I.1.b.e 1811 Oak Bay Avenue - Development Permit with Variance Application No. 00060 (Gonzales)

To: Committee of the Whole **Date:** July 11, 2019
From: Andrea Hudson, Acting Director, Sustainable Planning and Community Development
Subject: **Development Permit with Variances Application No. 00060 for 1811 Oak Bay Avenue**

re 1811 Oak Bay Avenue
Development Permit with Variances Application No. 00060
Response to Advisory Design Panel Recommendations

2 LEVEL 3 FLOOR PLAN
D10
D07
1:100

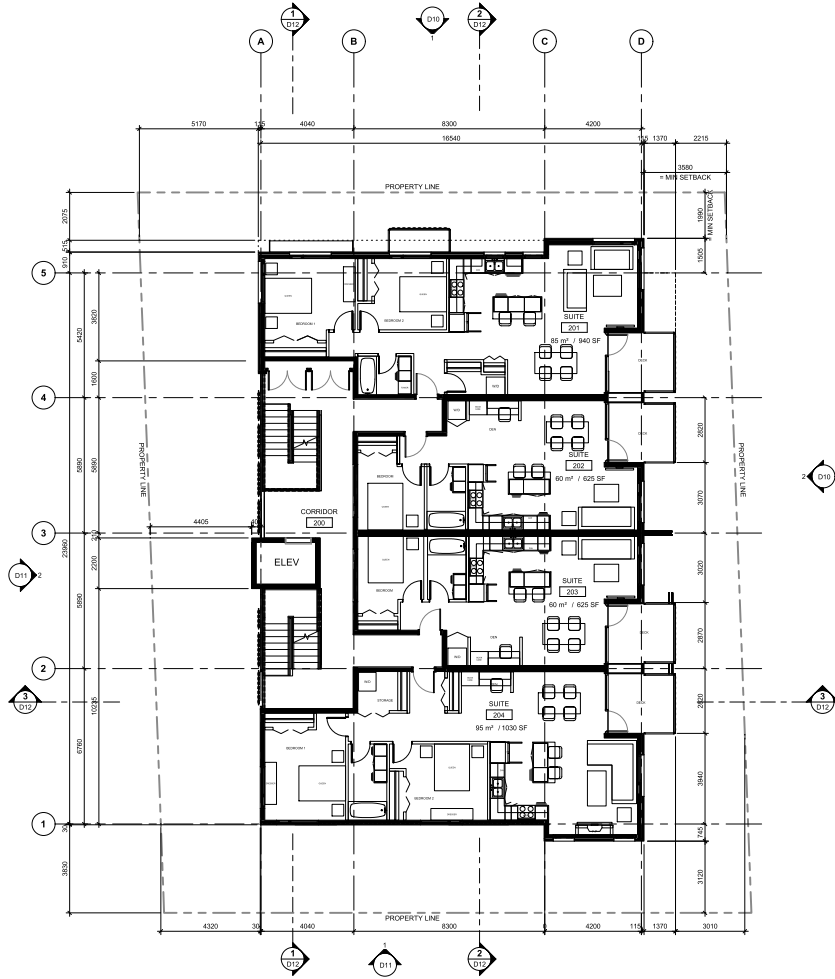
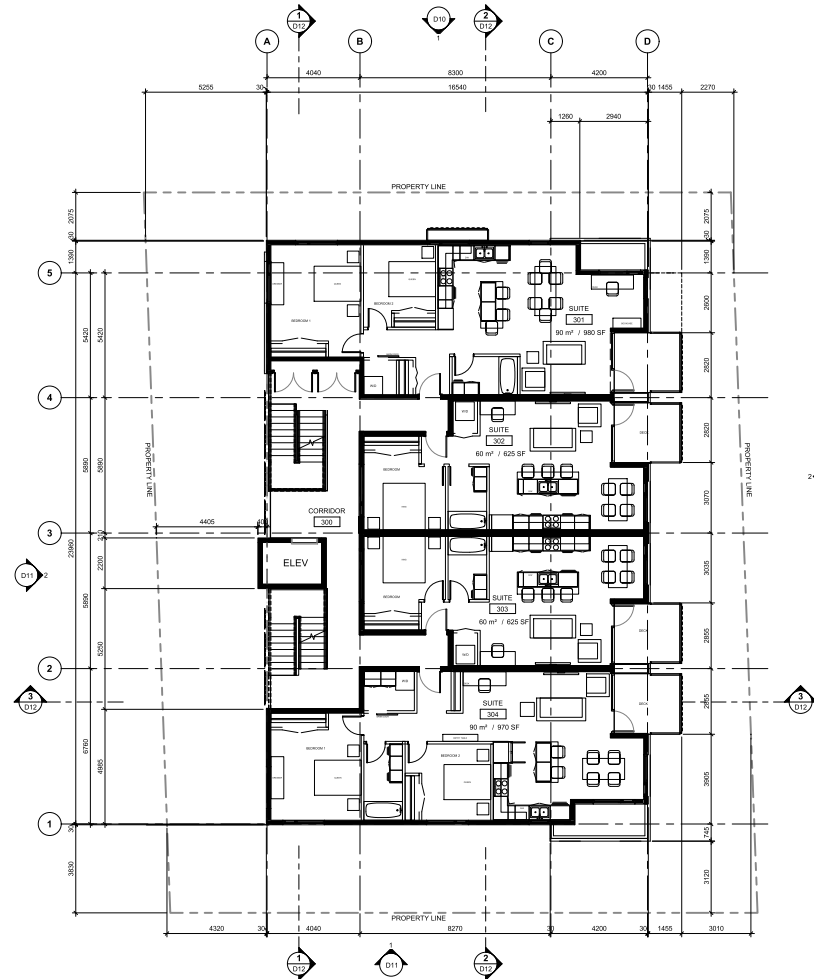
- the level 3 floor plan shows a full window in the bedroom and kitchen; is this correct?
 - this may be a coordination error; the large windows are intended for either living spaces or bedrooms
